Service Bulletin SB.JS-009

Inspection of tailplane captive bolt

MODEL	SERIAL NUMBERS
JS1A	N/A
JS1B	010 – 033

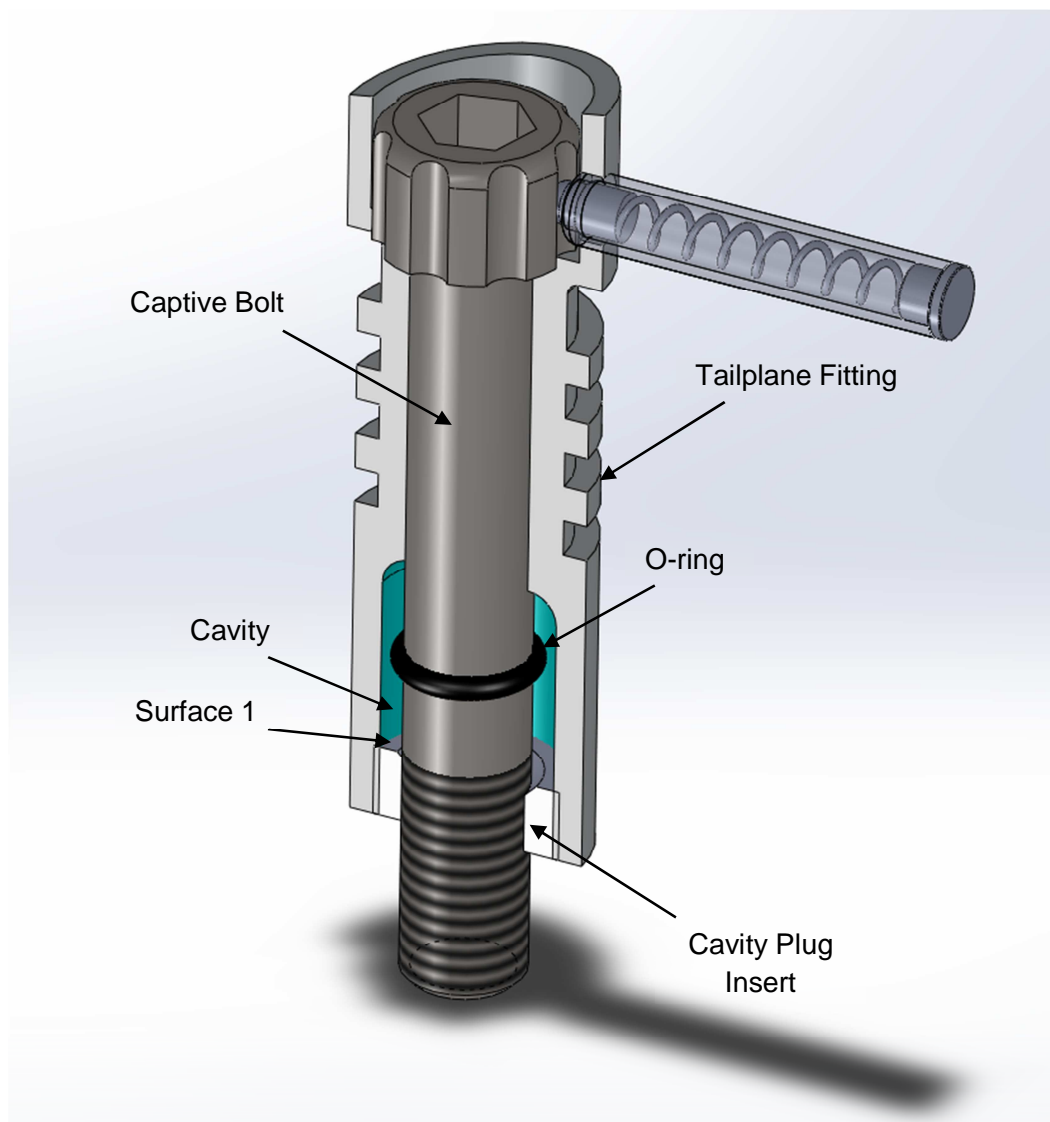
Check if the tailplane bolt is captive by inverting the tailplane and that the bolt does not fall out. The O-ring is normally stretched over the bolt shank in the cavity to ensure that the bolt is unable to slide out.

If the bolt is not captive it is recommended to follow this procedure to reinstall the O-ring.

- 1) Remove the tailplane bolt from tailplane Insert O-ring into bolt hole from top of tailplane. The O-ring will drop into the cavity. Ensure that the O-ring lies level on the bottom surface edge of the hole(Surface 1).
- 2) Install the bolt from the top and push down lightly on the O-ring, so that it slides up the bolt.
- 3) If the O-ring does not slide onto the bolt, hold the bolt in position on top of the O-ring. Gently press the O-ring onto the bolt using a thin rod or equivalent to press against while turning the bolt clockwise. NB, the O-ring will be damaged if forced over the bolt.
- 4) Re-check that the bolt is captive by inverting the tailplane and checking that the bolt does not fall out.
